Model: Model K3		Date: 1-Nov-02	No.: MH310001
Modified Article: Parts Catalog Corrections		Prepared by: M. Mano	
From: Technical Services sec. Service Planning Dept.			
Reason for Modification:	<input checked="" type="checkbox"/> Parts catalog correction <input type="checkbox"/> To facilitate assembly <input type="checkbox"/> Part standardization	<input type="checkbox"/> Vendor change <input type="checkbox"/> To improve reliability <input type="checkbox"/> Other	<input type="checkbox"/> To meet standards ()

Model: Model K3		Date: 9-Jan-03	No.: MH310002
Modified Article: Parts Catalog Corrections		Prepared by: M. Mano	
From: Technical Services Sec. Service Planning Dept.			
Reason for Modification:	<input checked="" type="checkbox"/> Parts catalog correction <input type="checkbox"/> To facilitate assembly <input type="checkbox"/> Part standardization	<input type="checkbox"/> Vendor change <input type="checkbox"/> To improve reliability <input type="checkbox"/> Other	<input type="checkbox"/> To meet standards ()

Part Change Information List

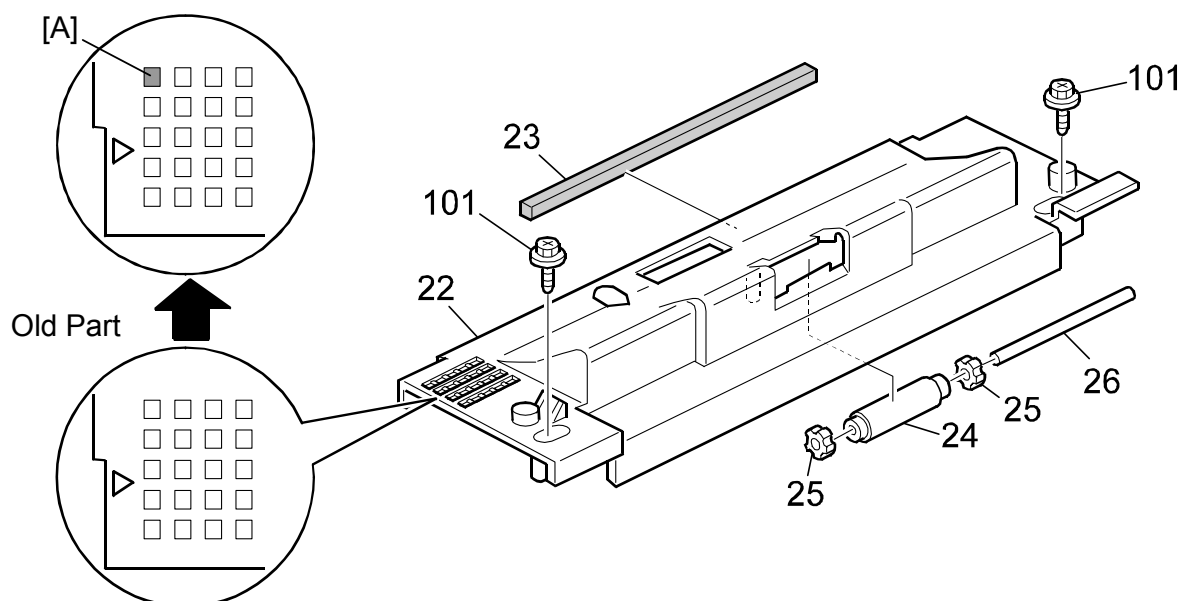
To facilitate assembly, the hole in the Exit Guide shown below has been closed (with no change in function).

New Part: The shaded hole [A] is closed

Old part number	New part number	Description	Q'ty	Int	Page	Index	Note
H3101196	H3101199	Exit Guide	1	X/O	15	22
